PROJECT TITLE: Energy Upgrades Project
Bullard Havens Regional Vocational Technical School

PROJECT NO.: BI-2B-317

BID OPENING	**1:00 P.M.**	**10-06-2009**
ADDENDUM NUMBER 3	**DATE OF ADDENDUM**	**SEPTEMBER 25, 2009**

BID OPENING	**1:00 P.M.**	**9-24-2009**
ADDENDUM NUMBER 1	**DATE OF ADDENDUM**	**SEPTEMBER 16, 2009**

LS-301 Wiring Schematic

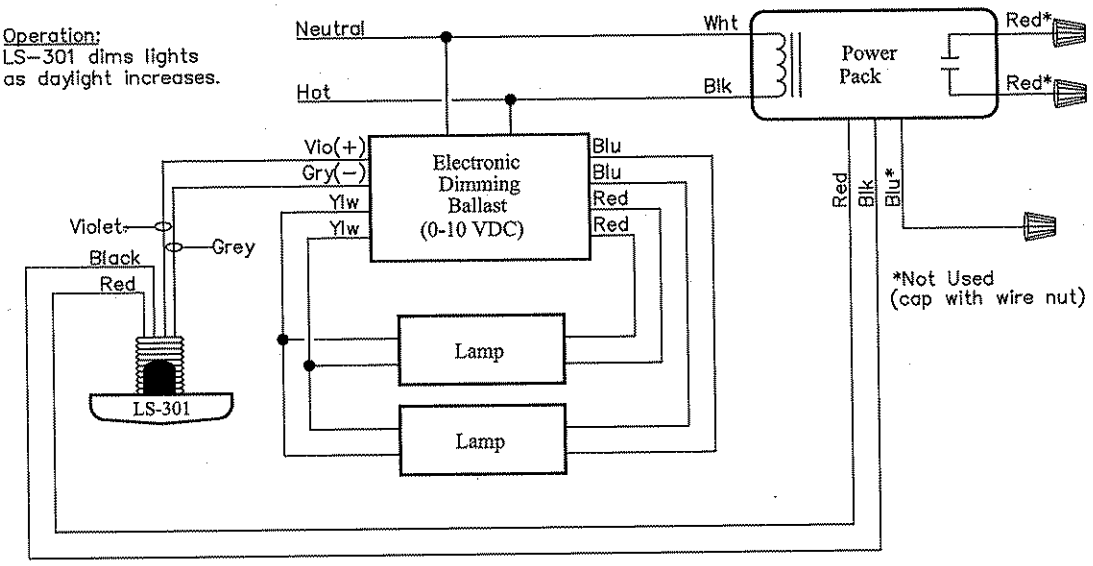
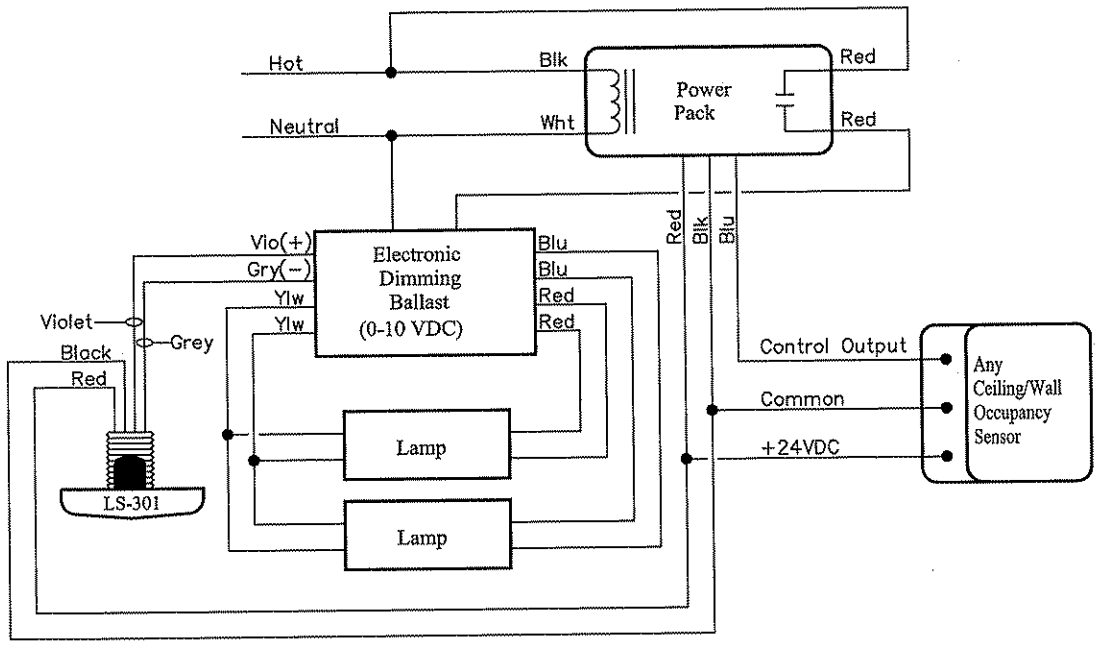
Drawing EG-2: Add wiring diagram for LS-301 Dimming Photosensor. See attached SKE-3

Operation:
LS-301 dims lights as daylight increases.

Operation:
Occupancy Sensor switches Lights ON/OFF. When occupied, the LS-301 dims the lights as daylight increases.

BRIDGE LIGHTING PLAN

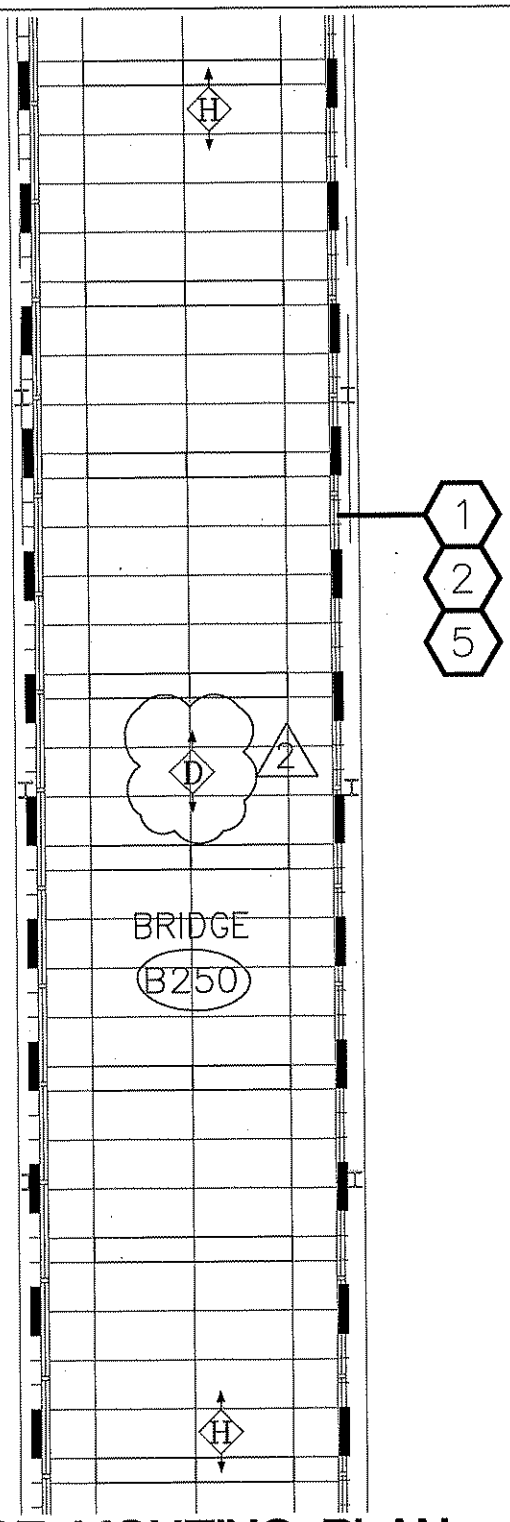
a. Add to Electrical Keyed Notes #1: "Replace Lamp Sockets as Necessary" See attached SKE-5
b. Revise Electrical Keyed Notes #1 & 2 to include: "Replace existing ballasts with electronic Programmed Rapid Start Ballasts" See attached SKE-5
c. Change symbol for sensor at center of "bridge" from "H" to "D" See attached SKE-6

GROUND FLOOR LIGHTING & POWER PLAN - BUILDING "A"

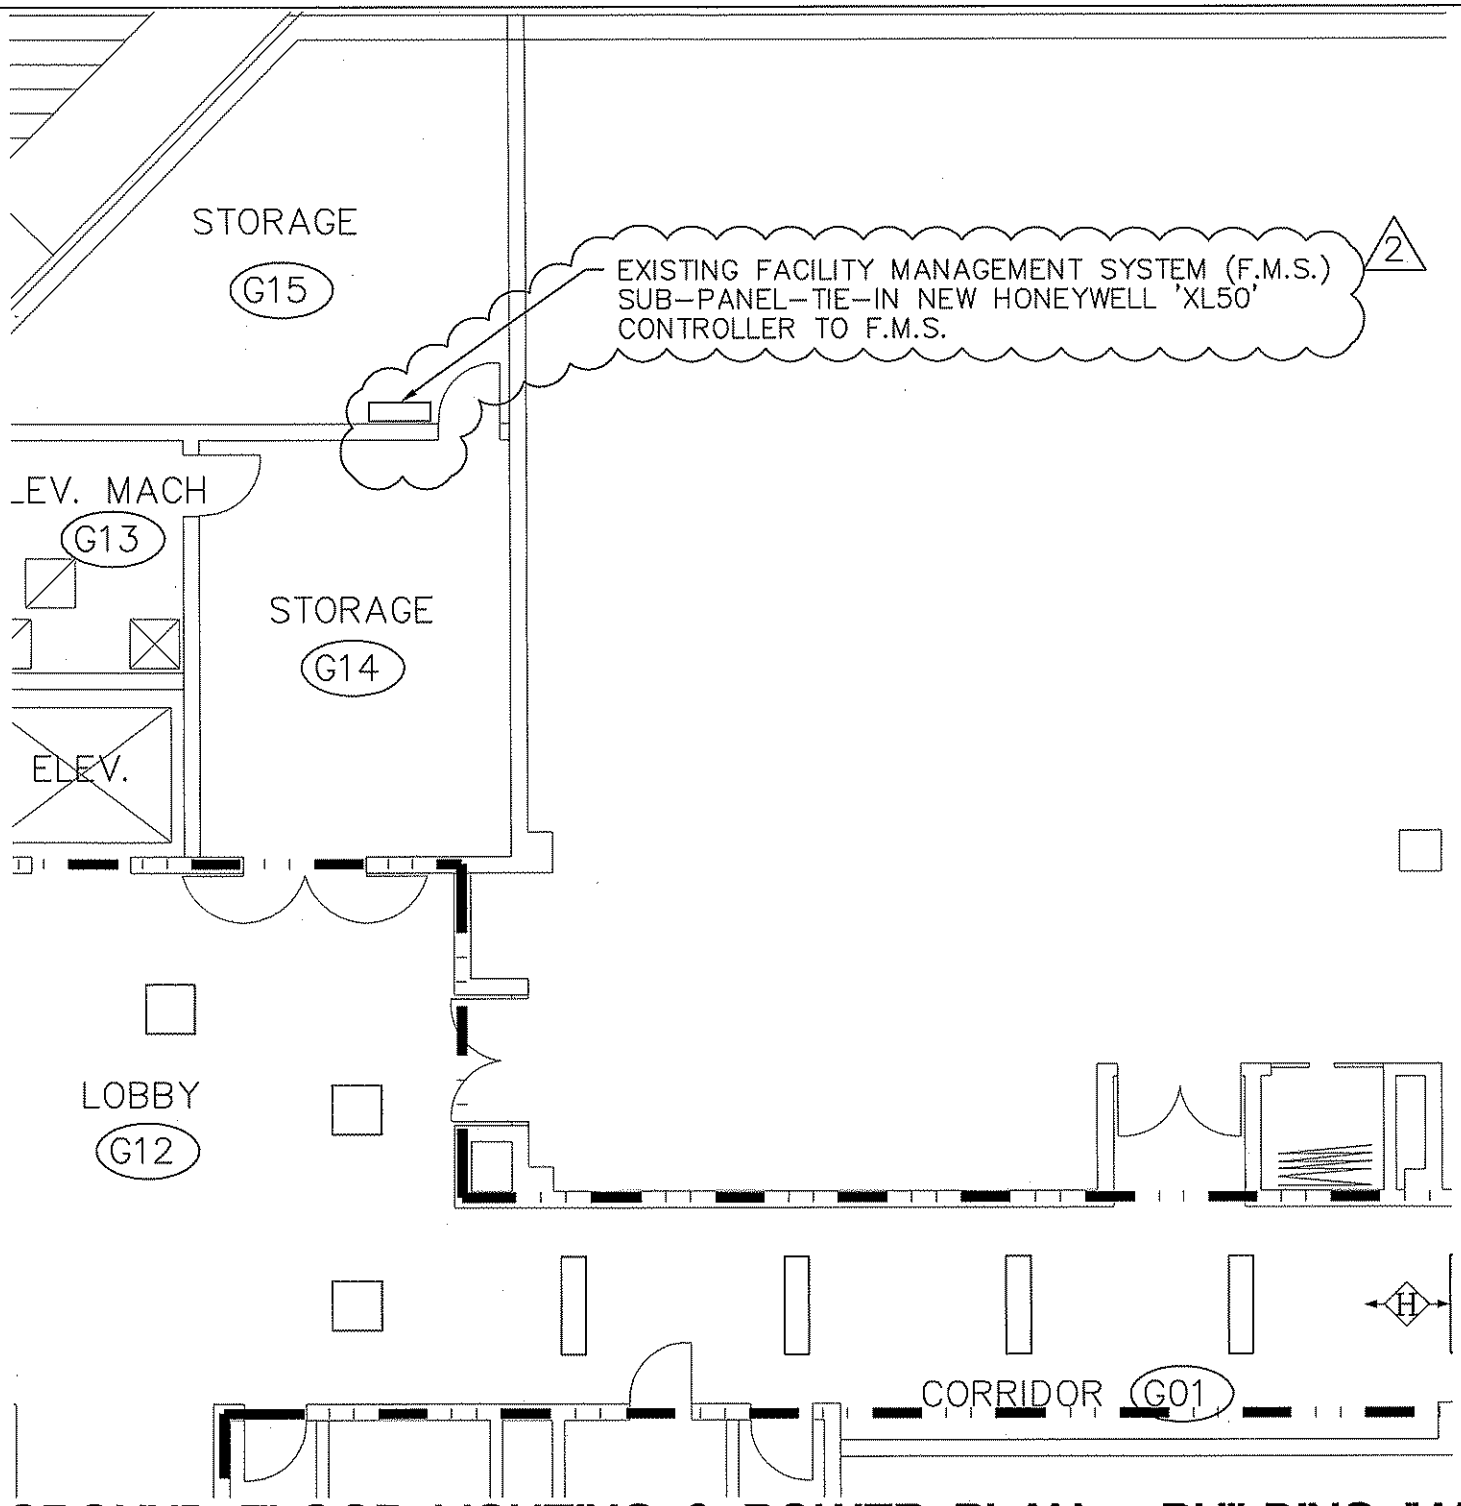
Show location of Facility Management System Sub-panel on plan. See attached SKE-17
